Anacapa Residence Hall Fire Safety and Renewal,
Bldg 547
Project No. FM130245L/988650
Addendum No. 2

Enclosed is **ADDENDUM NO. 2** to the Construction Documents on the above-captioned project.

ADDENDUM NO. 2

UCSB DWG #	AD
547-114	
DATE	2.10
04/10/13

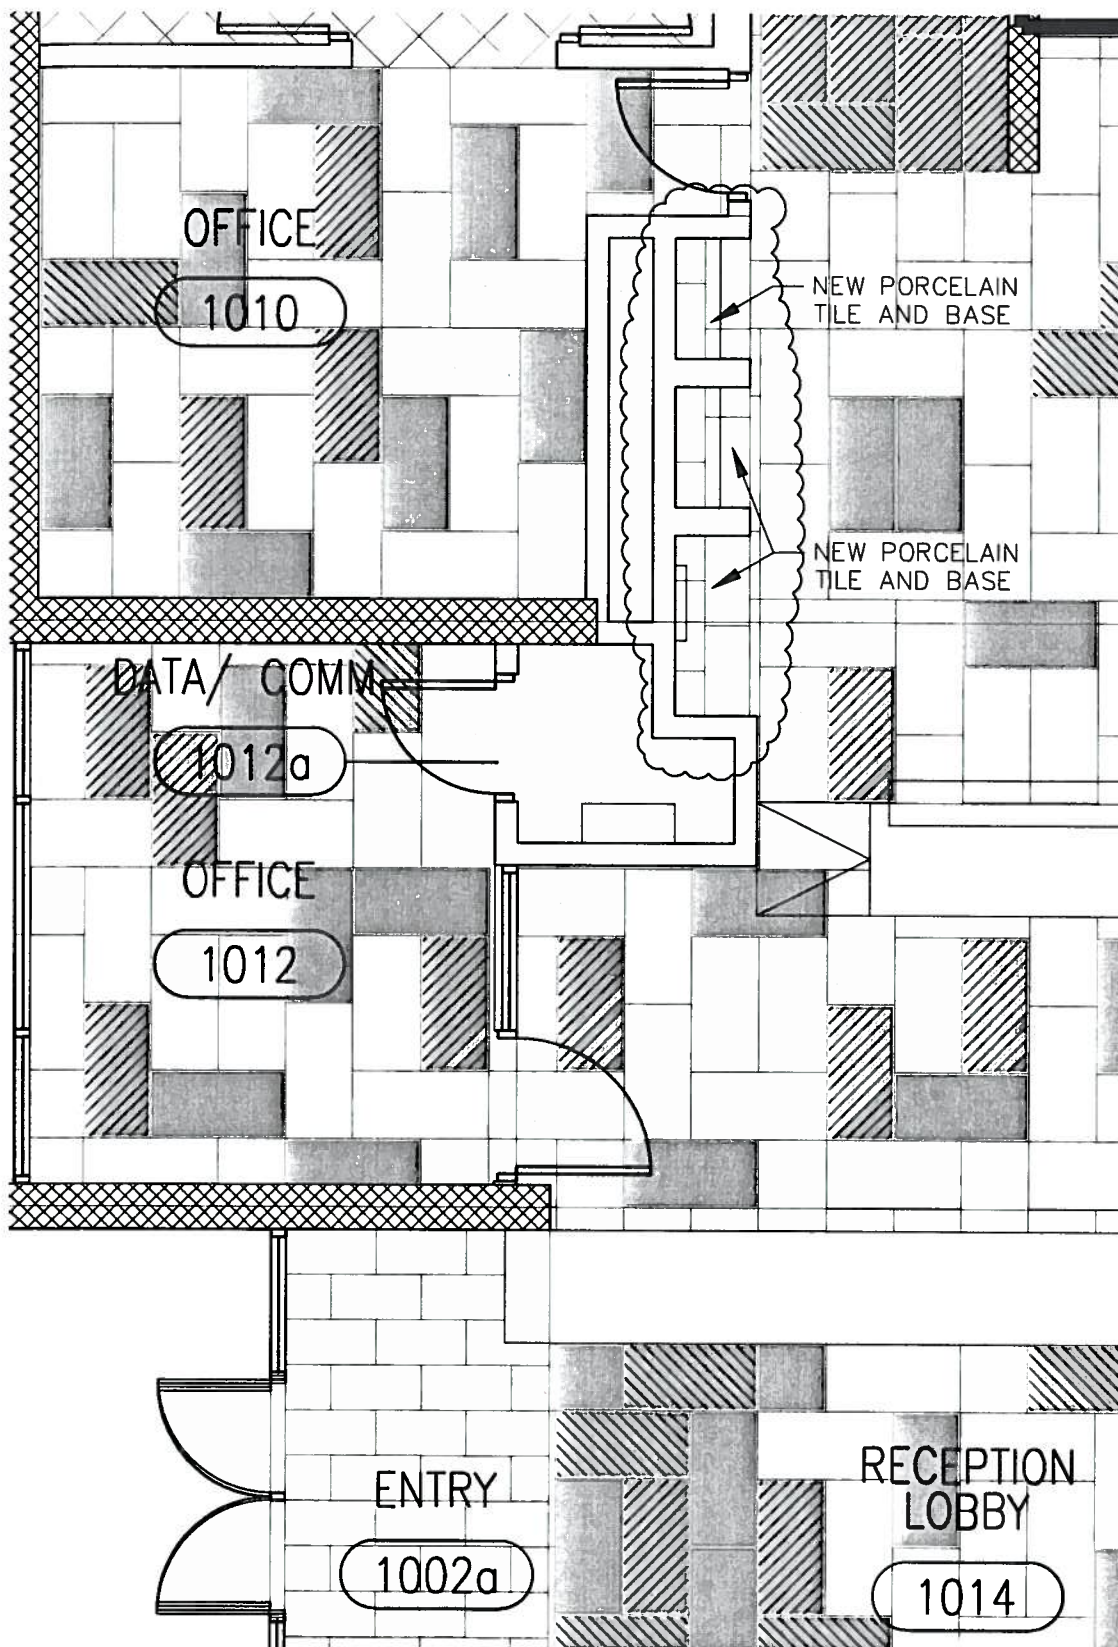
17. ARCHITECTURAL SHEET A211 Finish Plan – 1st Floor Area B:
REVISE Flooring finish in Reception Lobby alcoves per attached drawing AD2.10.

UCSB DWG #	AD
547-114	2.1
DATE	
04/10/13

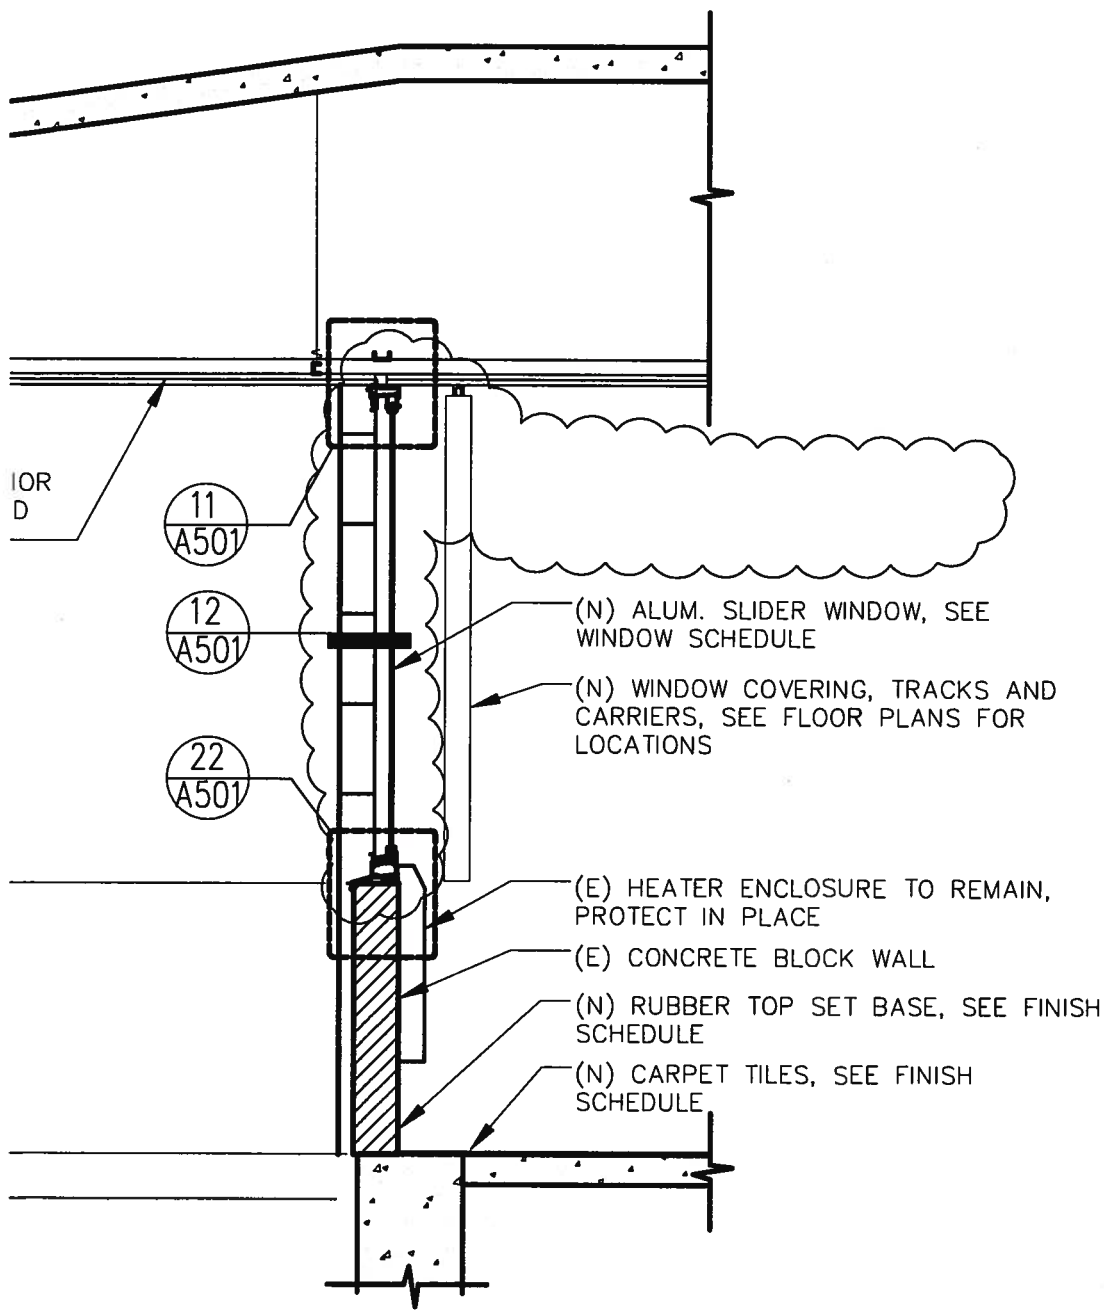
20. ARCHITECTURAL SHEET A302:
REVISE Wall Section 25 per attached drawing AD2.11.

53
 A602

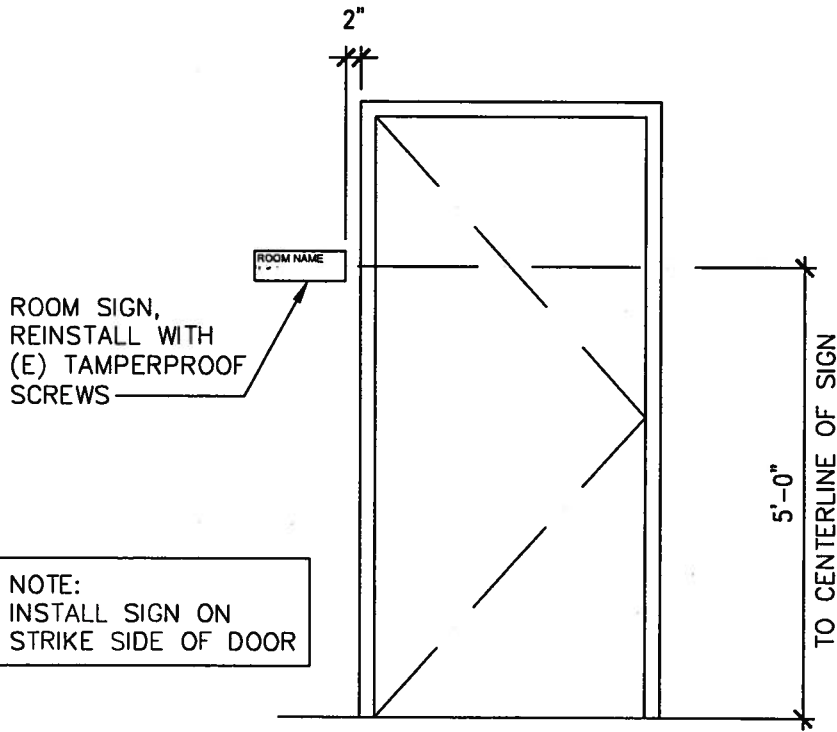
ADD signage mounting detail 53 per attached drawing AD2.12.

UCSB DWG # 547-114	AD
DATE 04/10/13	2.13

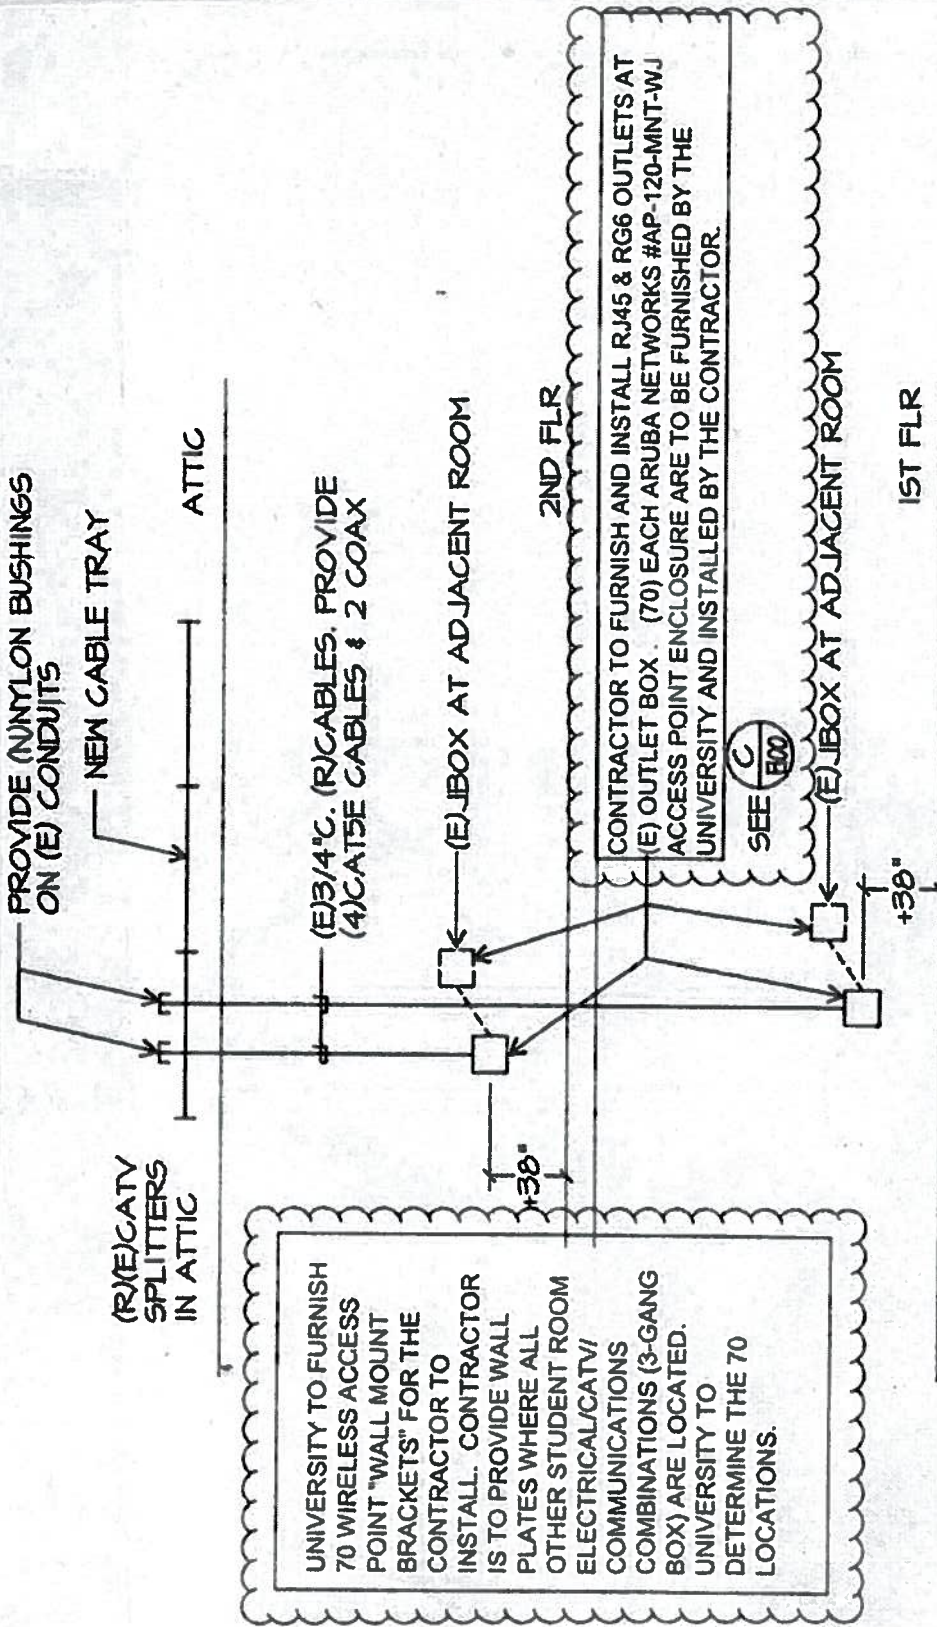
REVISE Typical Communications Riser detail D per attached drawing AD2.13.
